# Final Safety Evaluation Report

Related to the Certification of the Advanced  
Boiling Water Reactor Design

## Appendices

U.S. Nuclear Regulatory Commission  
Office of Nuclear Reactor Regulation

Figure G-1 Stability curves for axially loaded compression members,  $E = 200 \text{ GPa (29,000 ksi)}$

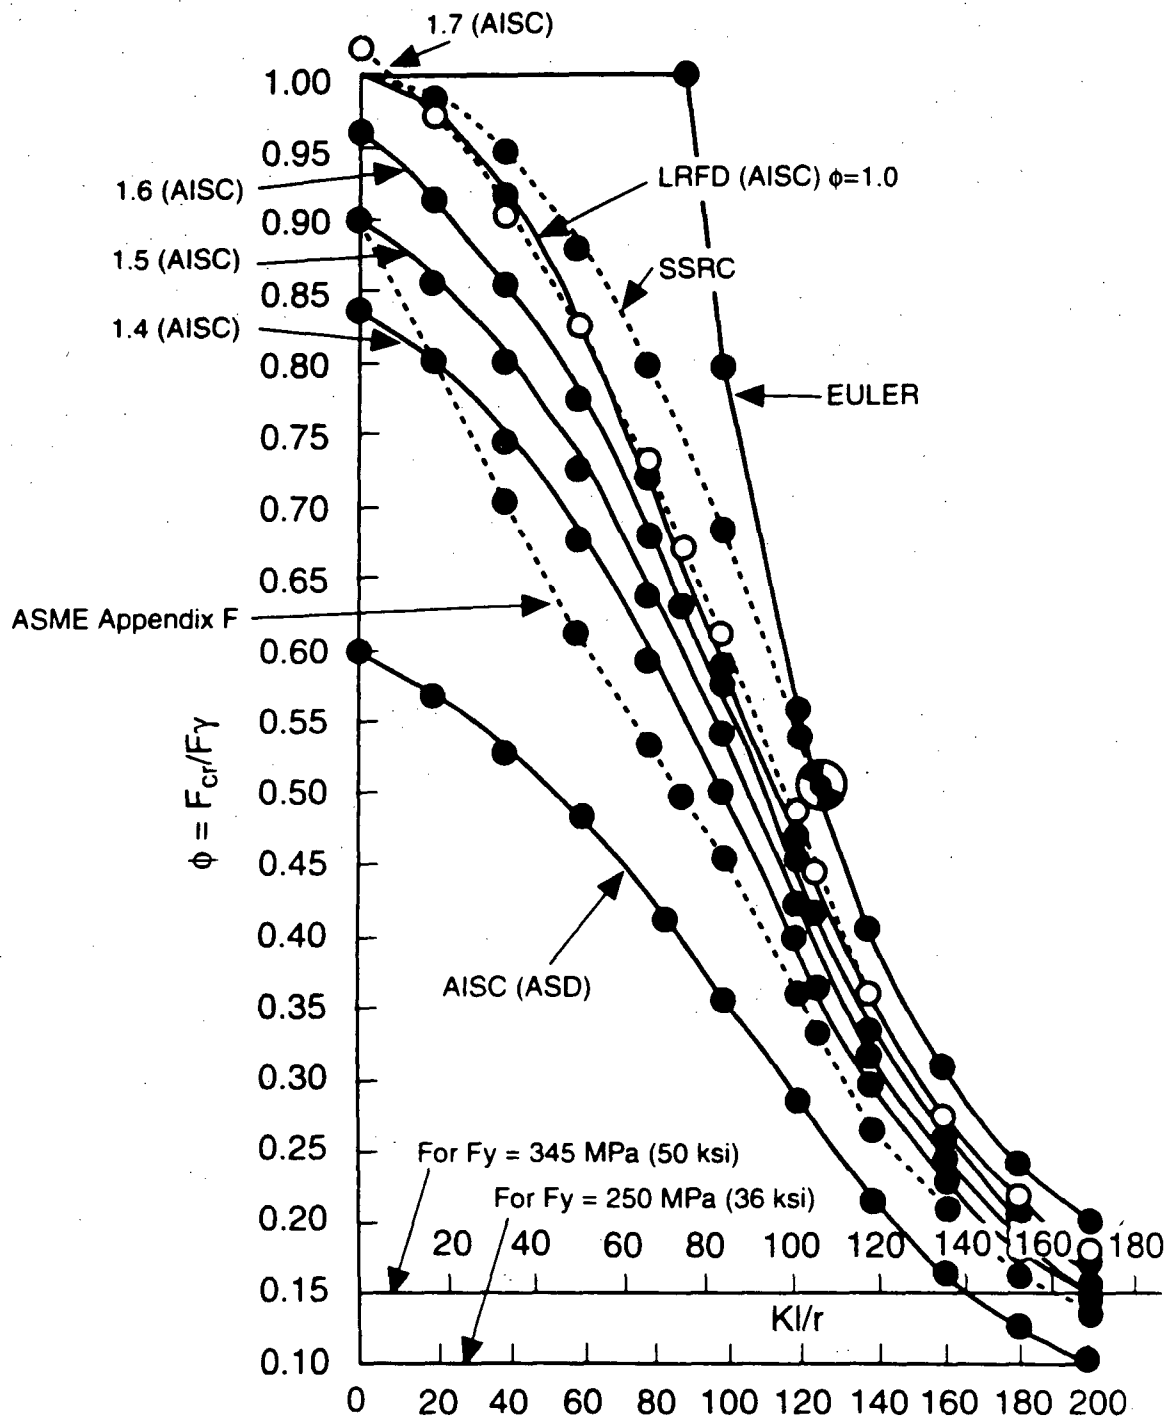
- (3) The research done in the last 12 years on the strength and stability of compression members indicates that the base curve (Structure Stability Research Council (SSRC) curve in Figure G-1 of this appendix) used in arriving at the SLCs in SRP Sections 3.8.3 and 3.8.4 and in the standard does not reflect available test data. In developing the American Institute of Steel Construction (AISC) building specification based on the load and resistance factor design (LRFD) concept, the AISC changed the formula for compression members to reflect the test data. The LRFD curve (with  $\phi=1.0$ ) is also shown in Figure G-1. On the basis of the test data, this curve has a minimum reliability index,  $\beta^1$  of 2.6 (American Institute of Steel Construction, "Load and Resistance Factor Design Specification for Structural Steel Buildings and Its Commentary," Chicago, Illinois, September 1, 1986). The LRFD specification requires  $\phi=0.85$  in establishing the resistance of compression members.

Figure G-1 shows the curves reflecting the SLCs of 1.0, 1.4, 1.5, 1.6 and 1.7 as applied to the stresses specified for the allowable stress design (ASD) of AISC. On the basis of the comparison with the LRFD curve( $\phi=1.0$ ), the following SLCs are recommended:
